**RE: EL SEGUNDO ENERGY CENTER PROJECT
DOCKET NO. 00-AFC-14C
45TH STREET BERM DRAWINGS TO SUPPORT JOINT
STATEMENT OF AGREEMENT**

Enclosures: Revised 45th Street Berm Drawing (Appendix B to the Temporary Landscaping and 45th St. Berm – VIS-9 landscaping Plan)
Revised Sheet 4 of Appendix A to the Temporary Landscaping and 45th St, Berm – VIS-9 Landscaping Plan)

EL SEGUNDO POWER
REDEVELOPMENT PROJECT

P-3

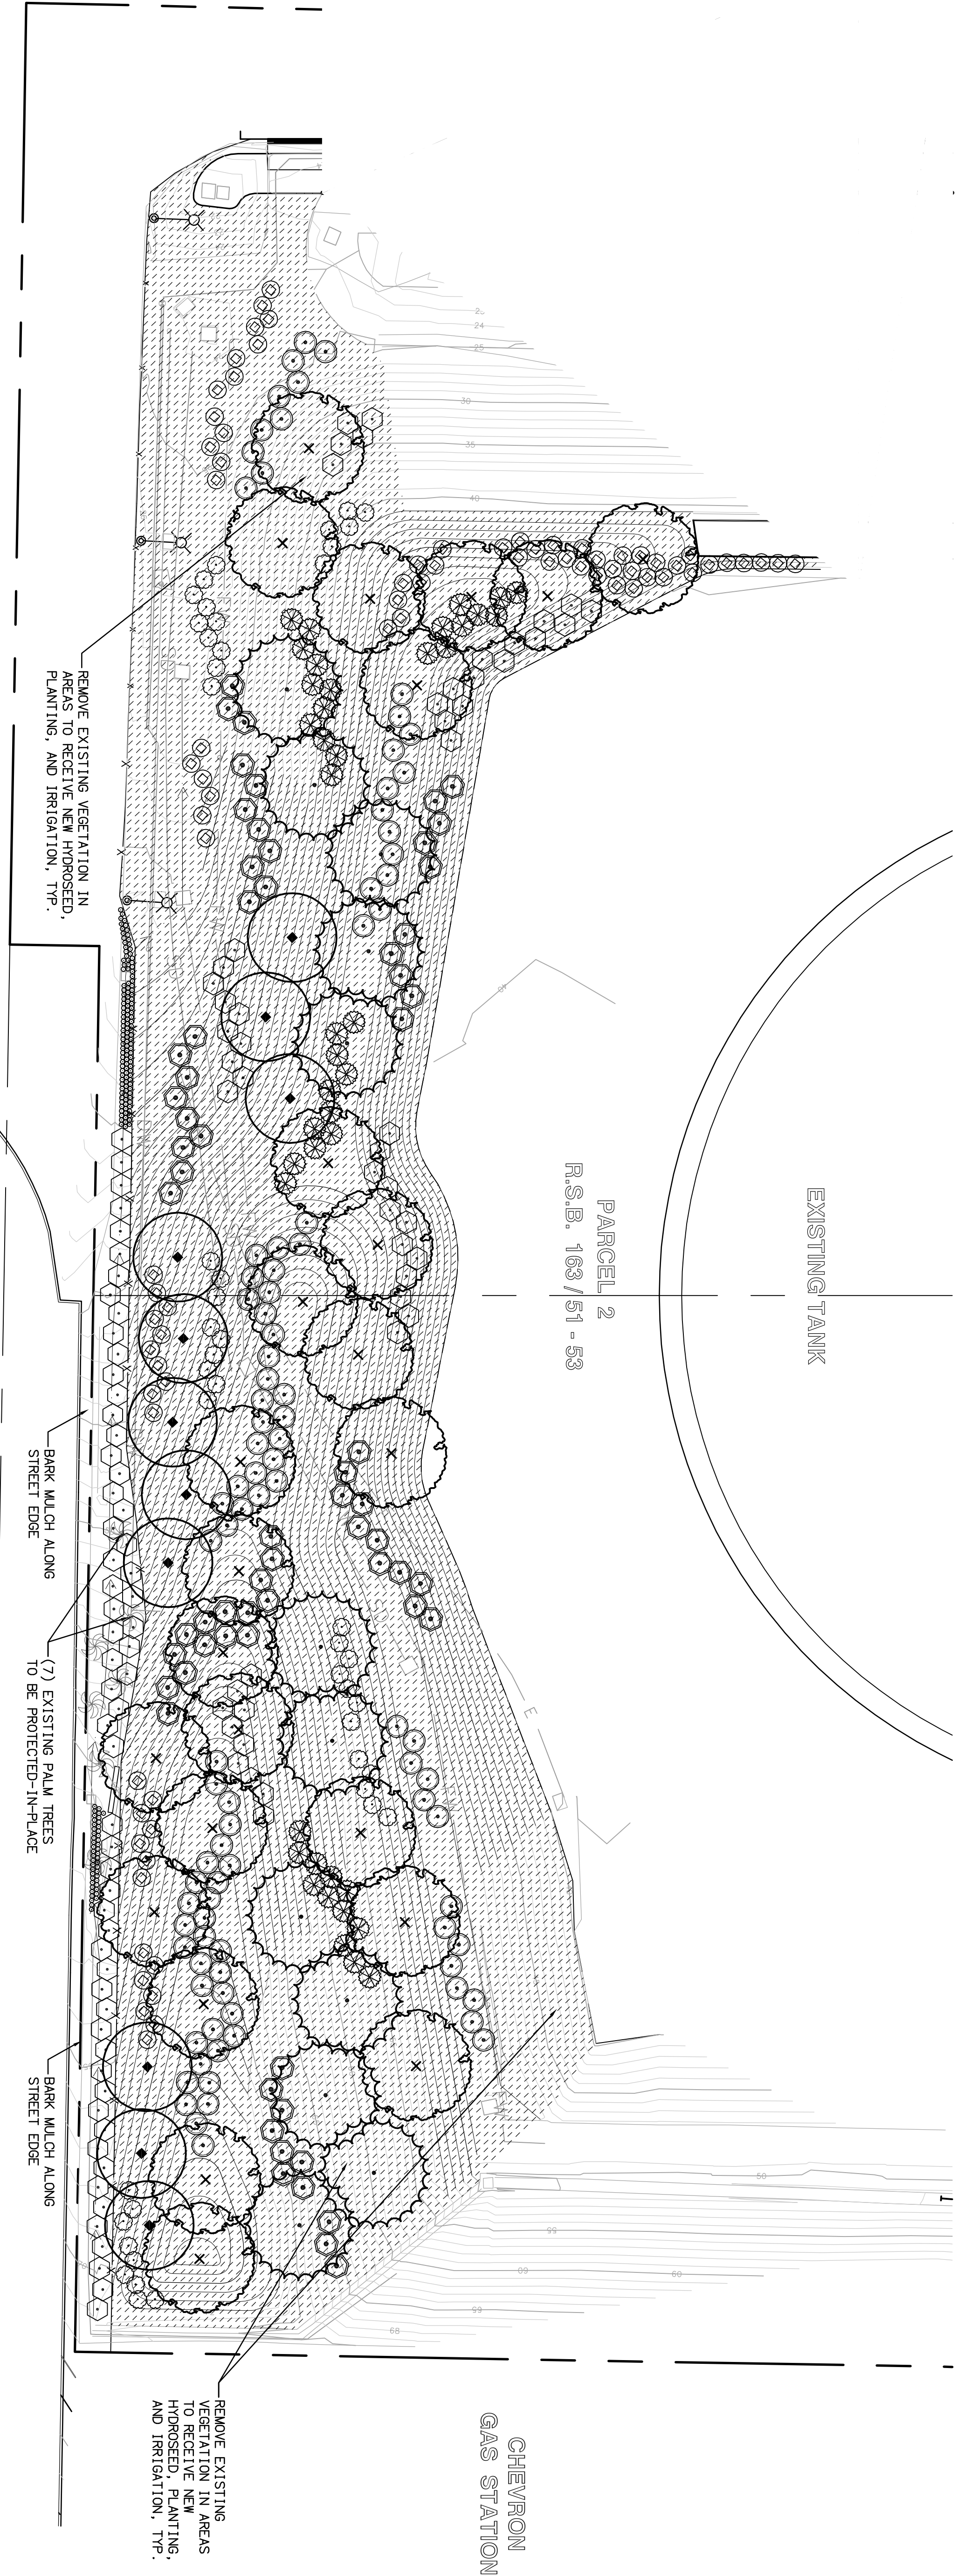
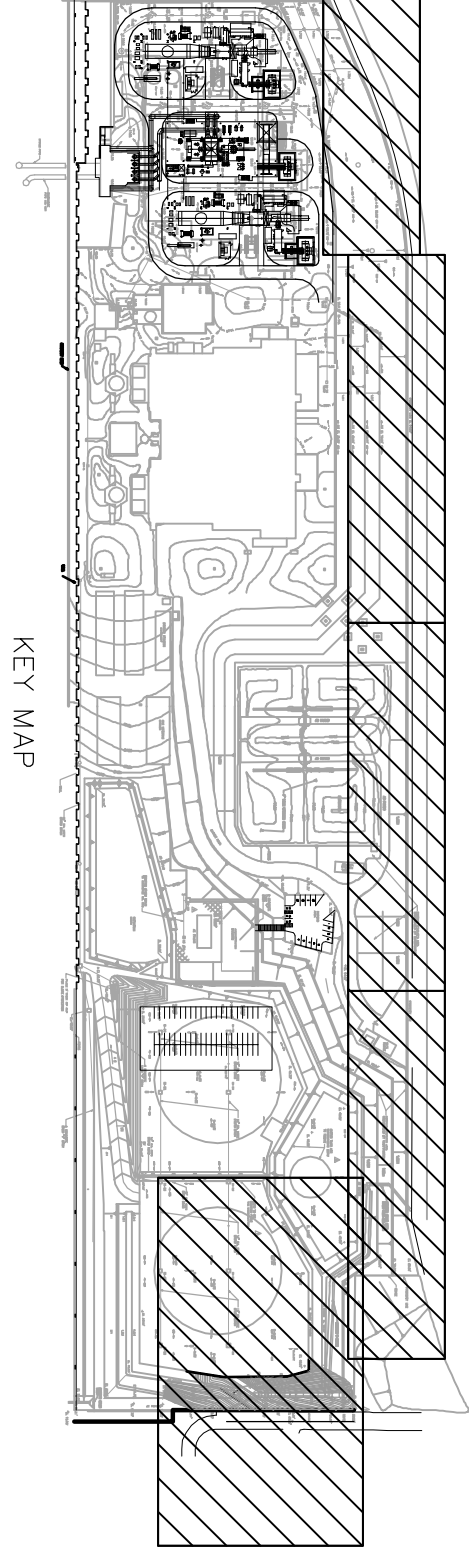
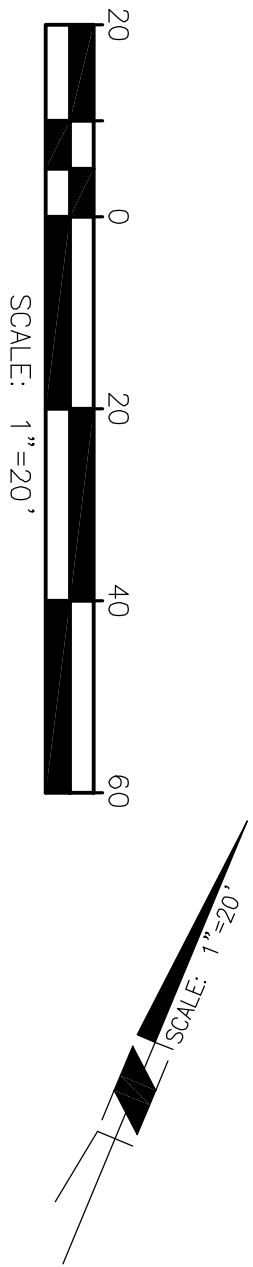
El Segundo Energy Center LLC (ESEC) submits the attached drawings illustrating the planned improvements to the 45th Street Berm for review/comment by the parties of the July 3, 2012 complaint and the Cities of Manhattan Beach and El Segundo and for approval by the CA Energy Commission Compliance Project Manager. These drawings address conditions 5 and 6 of the Joint Statement of Agreement, dated September 5, 2012 and VIS-9 of the Conditions of Certification. Specifically, ESEC submits the redesigned 45th Street Berm Drawing (Appendix B, Sheet 1 to the VIS-9 Temporary Landscaping and 45th St. Berm) per condition 5; this drawing reflects the increased slope steepness to pull the berm back from the existing palm trees. ESEC also submits revised Appendix A, Sheet 4 of the VIS-9 Temporary Landscaping and 45th St, Berm per condition 6; this drawing illustrates the revised berm slope and the final location of the permanent fence along the southern property boundary.

DATE	BY	DESCRIPTION	APPROVED	DATE					
11/26/12	RBF	REVISED PLANTING ON 45TH STREET BERM							
REVISIONS
